PUBLIC HEARING MEMORANDUM

SUBJECT: **Petition #223-22** for SPECIAL PERMIT/SITE PLAN APPROVAL to allow parking facility waivers including; to allow parking in the front setback, to waive interior landscape requirements and to waive lighting requirements in order to expand an existing parking area at **55-67 Border Street**, Ward 3, West Newton, on land known as Section 33 Block 13 Lot 17, containing approximately 38,036 sq. ft. of land in a district zoned MANUFACTURING. Ref: Sec. 7.3.3, 7.4, 5.1.8.A.1, 5.1.13, 5.1.9.B, 5.1.13, 5.1.10 of Chapter 30 of the City of Newton Rev Zoning Ord, 2017.

MEMORANDUM

Re: Special Permit – #55 Border Street

Proposed site plan

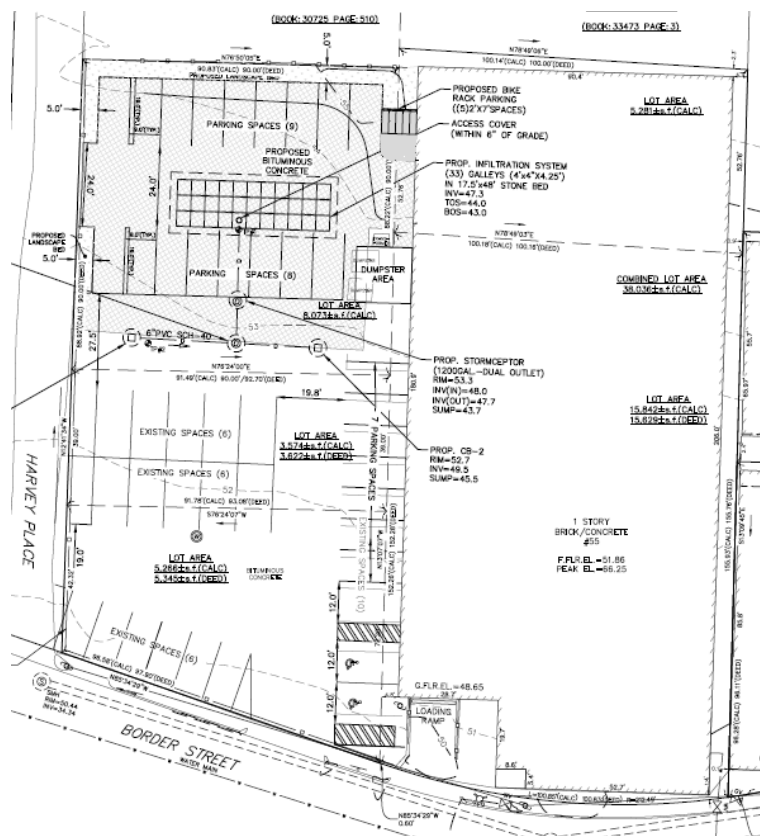
The site has frontage on both Harvey Place and Border Street, and, as proposed, several of the new stalls would be located in the front setback along the Harvey Street frontage. The parking would continue to be accessed via an existing curb cut on Border Street.

Proposed planting plan

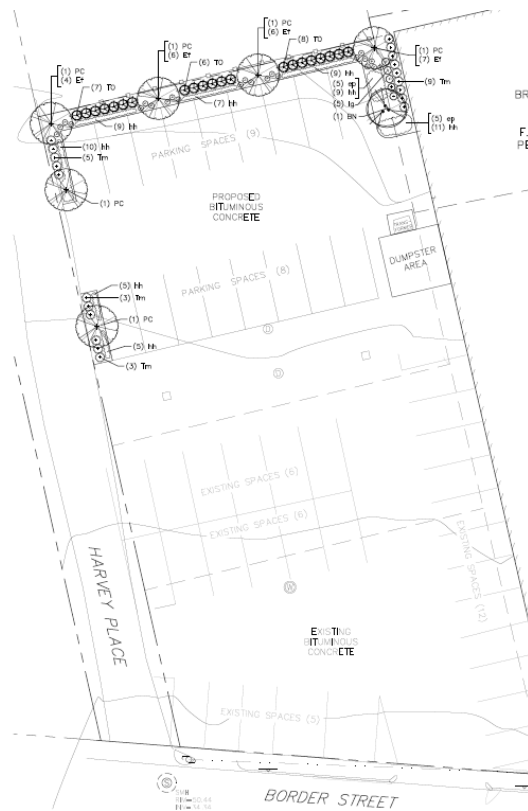
The petitioner submitted a planting plan with the petition that indicates 28 trees (including 21 arborvitae) would be installed, mostly along the property line shared with the residential property that abuts directly to the north. The Planning Department requests the petitioner clarify if a fence would also be located along that boundary.

Parking stalls appear to be encroaching Harvey Place

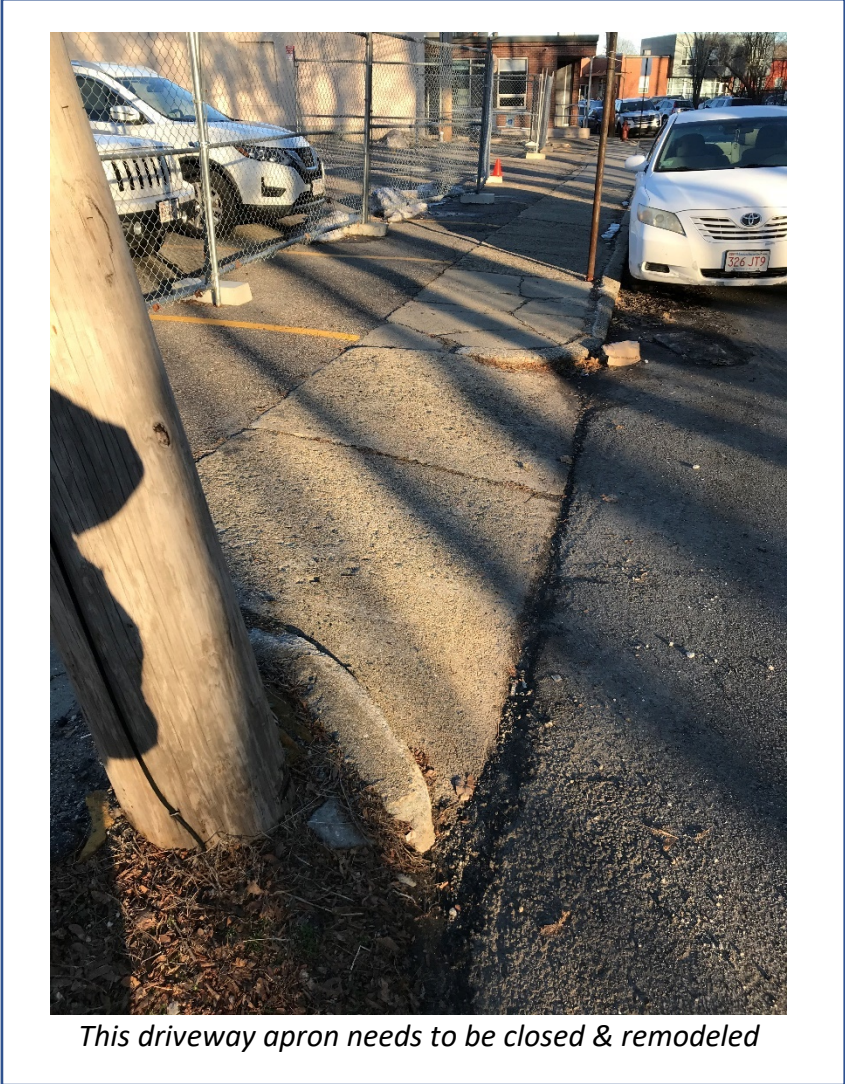
Based on a site visit the parking lot appears to be encroaching Harvey Place, some sort of delineation such as curbing should be installed at the edge of the parking lot to define the limits.

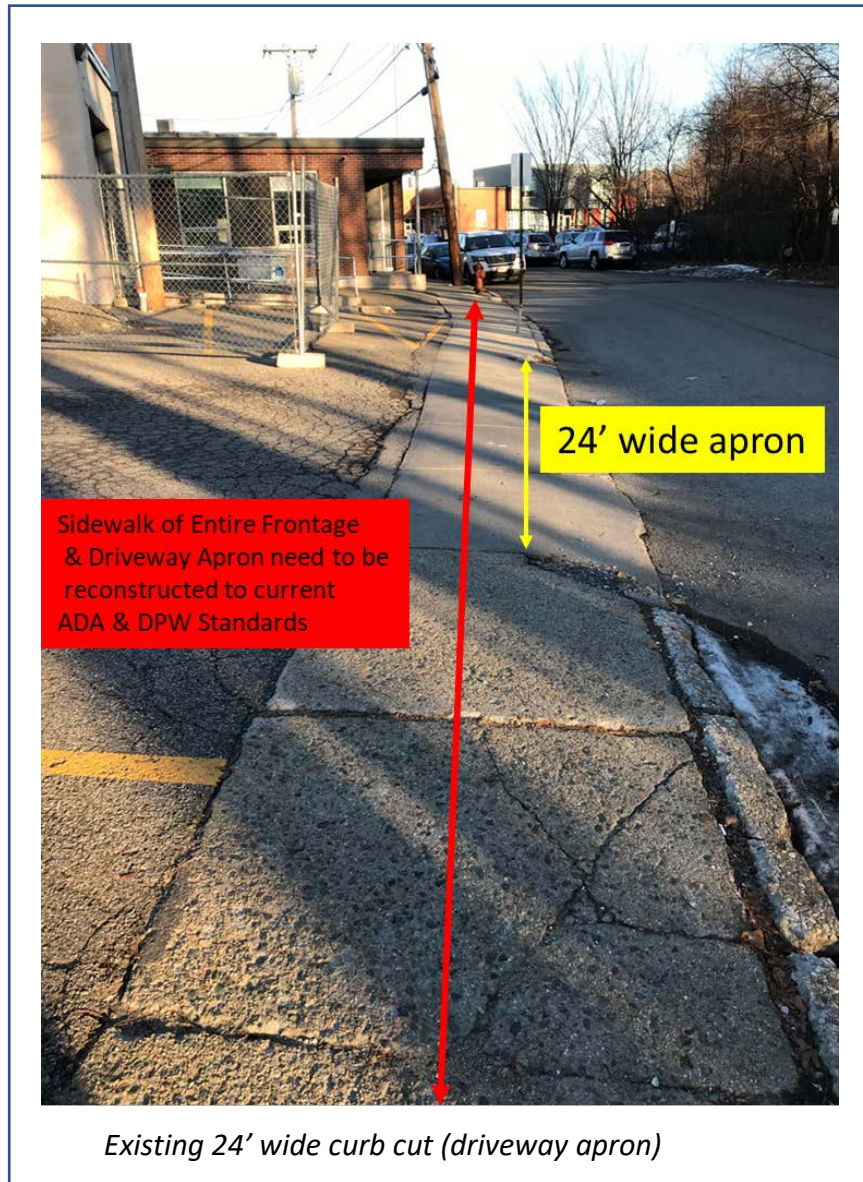
The existing driveway curb cut at the corner of Border Street & Harvey Place needs to be eliminated and remodeled as sidewalk since parking stalls are juxtaposed to this apron; the main driveway has an existing 24' wide curb cut that can accommodate two-way traffic in and out of the parking lot.

Sidewalks along the entire frontage are not compliant and need to be updated to current ADA and DPW Standards as part of the Special Permit, see photo on following page.
